<b>Title of Change:</b>	Narrow sealing 3M cover tape (2681) for tilted die reduction.	
<b>Proposed First Ship date:</b>	30 Nov 2020 or earlier if approved by customer	
<b>Contact Information:</b>	Contact your local ON Semiconductor Sales Office or <a href="mailto:Gunalan.Chandiran@onsemi.com">Gunalan.Chandiran@onsemi.com</a>	
<b>PCN Samples Contact:</b>	Contact your local ON Semiconductor Sales Office or <a href="mailto:PCN.samples@onsemi.com">PCN.samples@onsemi.com</a> Sample requests are to be submitted no later than 30 days from the date of first notification, Initial PCN or Final PCN, for this change. Samples delivery timing will be subject to request date, sample quantity and special customer packing/label requirements.	
<b>Type of Notification:</b>	This is an Initial Product/Process Change Notification (IPCN) sent to customers. An IPCN is an advance notification about an upcoming change and contains general information regarding the change details and devices affected. It also contains the preliminary reliability qualification plan. The completed qualification and characterization data will be included in the Final Product/Process Change Notification (FPCN). This IPCN notific

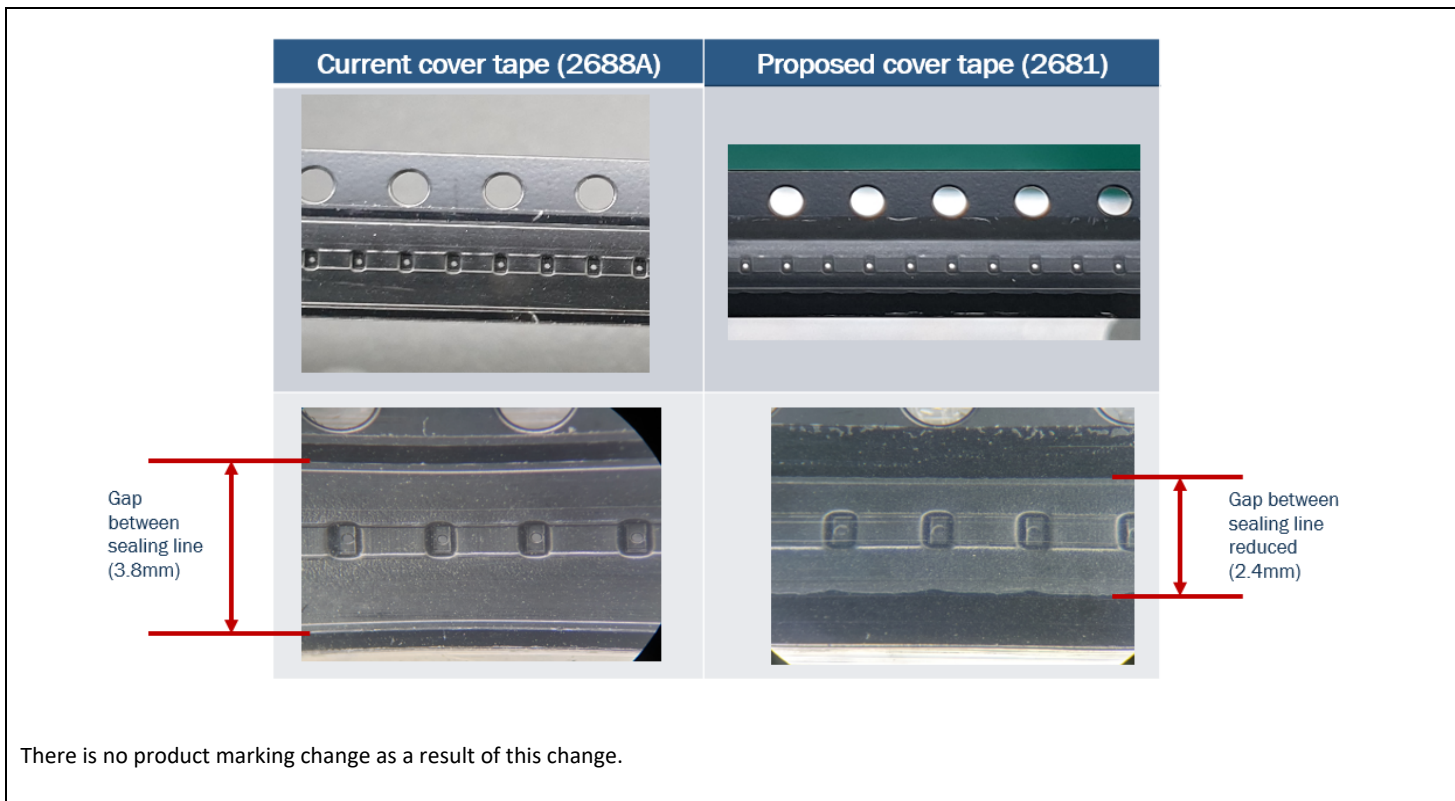
<b>Marking of Parts/ Traceability of Change:</b>	The affected products will be identified with date code	
<b>Change Category:</b>	Assembly Change	
<b>Change Sub-Category(s):</b>	Material Change	
<b>Sites Affected:</b>		
<b>ON Semiconductor Sites</b>	<b>External Foundry/Subcon Sites</b>	
ON Semiconductor Seremban, Malaysia	None	
<b>Description and Purpose:</b>		
Existing Cover tape 2688A (cold seal) having wider sealing gap, thus create doming effect on the carrier tape.		
This may results in tilted die if carrier tape mishandling happens.		
The proposed cover tape 2681 with narrow sealing gap will hold the die inside the pocket and reduce the doming effect.		
Objective is to eliminate tilted die.		
	<b>Before Change Description</b>	<b>After Change Description</b>
<b>Other Changes</b>	Cover tape 2688A	Cover tape 2681 with reduced sealing gap for better quality

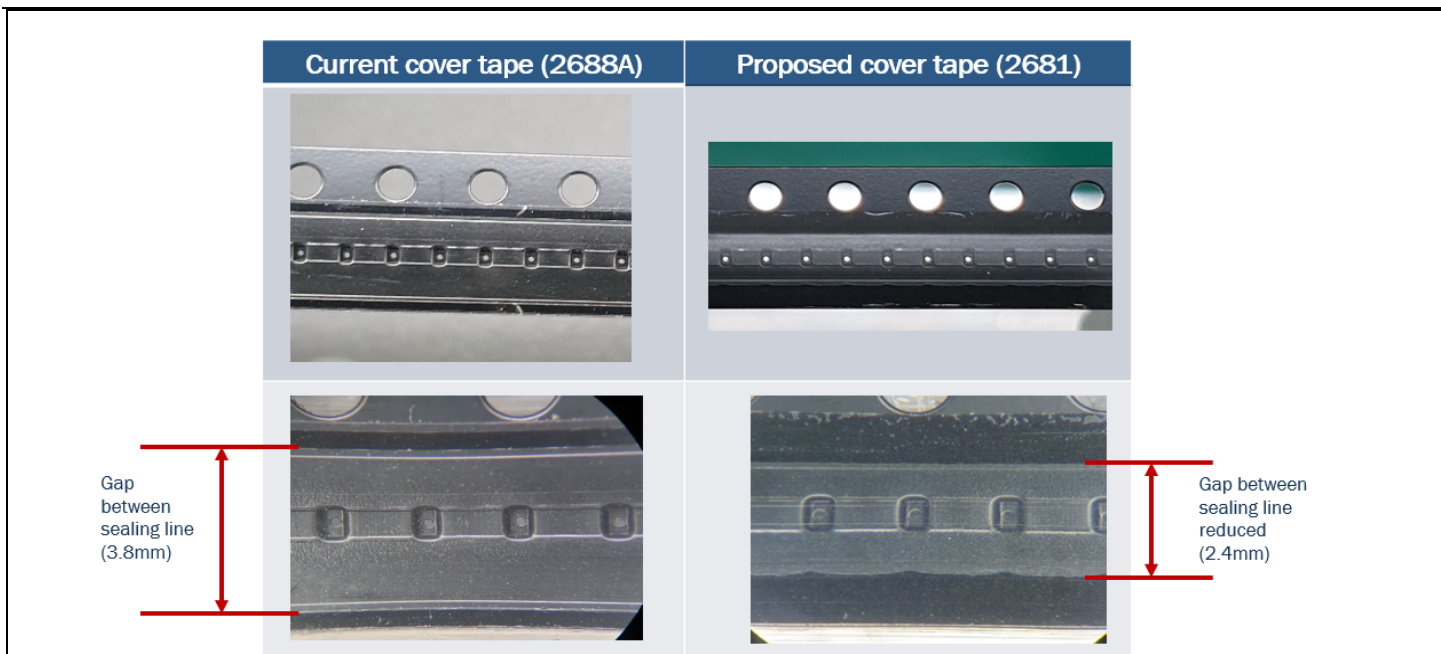
変更件名:	傾斜ダイ削減のための狭封止 3M カバーテープ (2681).	
初回出荷予定日:	30 Nov 2020 またはお客様からの承認が得られた場合はそれ以前	
連絡先情報:	現地のオン・セミコンダクター営業所または <a href="mailto:Gunalan.Chandiran@onsemi.com">Gunalan.Chandiran@onsemi.com</a> にお問い合わせください。	
サンプル:	現地のオン・セミコンダクター営業所または <a href="mailto:PCN.Samples@onsemi.com">PCN.Samples@onsemi.com</a> にお問い合わせください。 サンプルは、この変更の初回通知、初回 PCN の日付から 30 日以内に要求してください。 サンプル納入時は、依頼日、数量、特別梱包材/ラベル条件によって異なります。	
通知種別:	これは、お客様宛の初回製品 / プロセス変更通知 (IPCN) です。IPCN は、近日中に実施される変更に関する事前通知であり、変更の詳細および影響を受けるデバイスについての一般情報が記載されます。また、暫定的な信頼性認証計画も記載されます。 最終的な認定データおよび特性データは最終製品 / プロセス変更通知 (FPCN) に含まれます。この IPCN は、変更実施から少なくとも 90 日前に発行される最終製品 / プロセス変更通知 (FPCN) に先だって通知されます。ご不明な点がありましたら、 <a href="mailto:PCN.Support@onsemi.com">PCN.Support@onsemi.com</a> にお問い合わせください。	
部品のマーキング/変更のトレーサビリティ:	影響を受ける製品は日付コードで識別されます。	
変更カテゴリ:	アセンブリの変更	
変更サブカテゴリ:	材料の変更	
影響を受ける拠点:		
オン・セミコンダクター拠点:	外部製造工場 / 下請業者拠点:	
ON Semiconductor Seremban, Malaysia	なし	
説明および目的:	<p>封止間隔が広い既存のカバーテープ 2688A (コールド封止) は、キャリアテープにドーム効果をもたらします。</p> <p>キャリアテープ取扱いにミスが生じた場合に、これが傾斜ダイとなります。</p> <p>狭封止間隔の提案カバーテープ (2681) がダイをポケット内に保持し、ドーム効果を抑えます。</p> <p>目的は傾斜ダイを排除することです。</p>

変更前の表記	変更後の表記
その他の変更	Cover tape 2688A	品質向上のため削減した封止間隔の Cover tape 2681
